Tweed Valley Hospital Development

Addendum 1 to Design Report

Issued for: State Significant Development Application – Response to Submissions

130559-BON-CIV-RPT-006

Drawing Title
**SOIL AND WATER
MANAGEMENT PLAN**

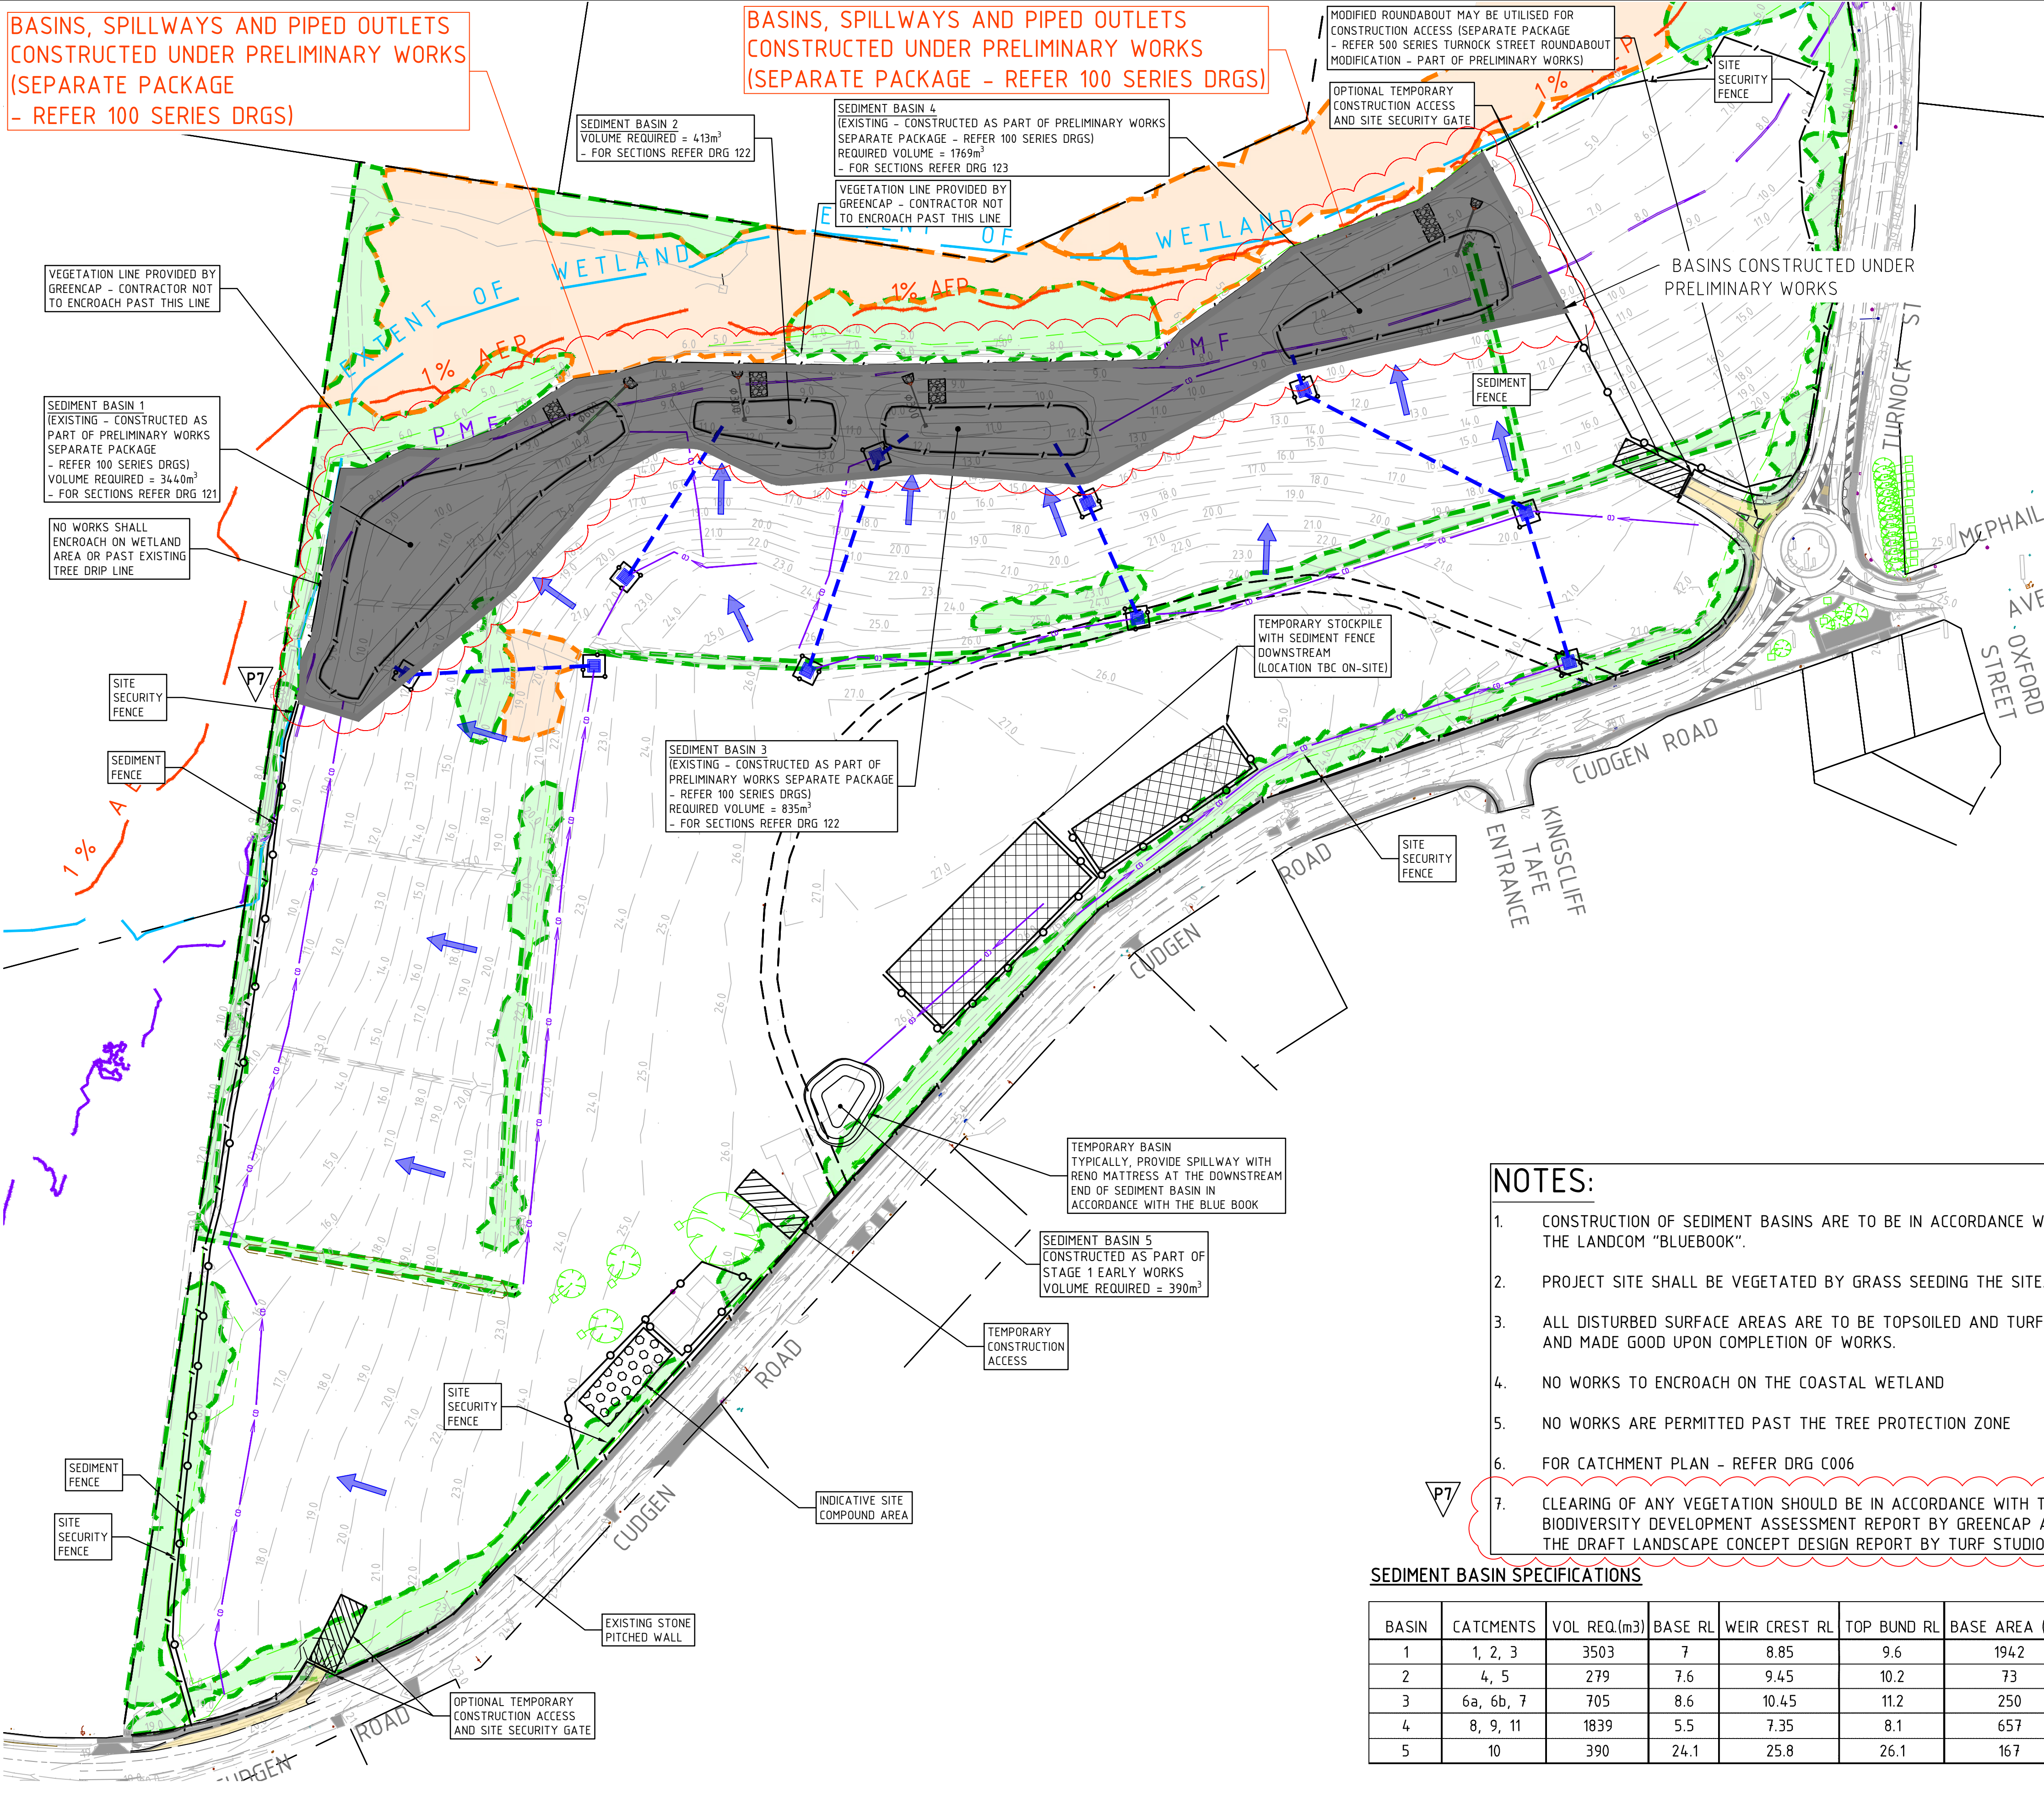
- *more detail is needed on the sedimentation pond design and the lawful point of discharge for the development.*
- *(Item tt) Details of the sediment basins and sizing calculations (drawings C0006 and C0007) are missing from the Civil and Structural Design Report (Appendix X) and should be provided.*

Drawings C005 to C009 have been updated and are provided at Appendix A of the Submissions Report.

Project Name	TWEED VALLEY HOSPITAL PRELIMINARY CIVIL WORKS
Drawing Title	BULK EARTH WORKS SECTIONS SHEET 1

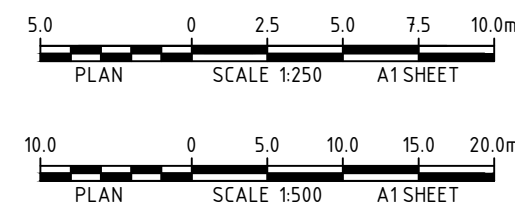
It noted that fill is proposed along the western section of the site as part of the Stage 1 works. The cut and fill details within Drawing number C011 Rev P4 is unclear and does not provide complete details of the proposed fill depth. However, it appears that up to 8m fill is proposed on the western side. It is anticipated that this fill is required to support the service road and the proposed car parking areas identified in the concept proposal. This should be clarified.

*The extent of cut and fill should be over laid on the survey plan and the areas of cut / fill should be hatched identifying the resultant levels after the landform modification.
The Response to submissions should also identify whether retaining walls or any form of batters are anticipated to be built in the future (or part of the Stage 1 works) to support the filled areas, especially on the western section, so that the extent of the proposed works (both for Stage and Concept Proposal) are clear. Should retaining walls be proposed as part of the Stage 1 works to support the filled areas in the western section of the site, then the details of the visual impacts of the retaining walls on the surrounding properties should be provided.
The Stage 1 works include benching of the site with a number of retaining walls. RLs of the top of the walls and sections through the site identifying the height of each of these retaining walls should be provided. Please clarify whether these retaining walls are required to accommodate the car parking areas in the future.*

- Sections of the site are provided on drawings C020, 021, 022 and 023. The sections show the general site grading to better visualise the proposed site levels.
- Typical retaining wall sections and details are shown on drawings C055 and 056. The sections are for retaining structures up to 3.40metres in height. The progression of the design aims to minimise the use of retaining structures and it is not proposed to have any retaining walls over 3.40metres in height.
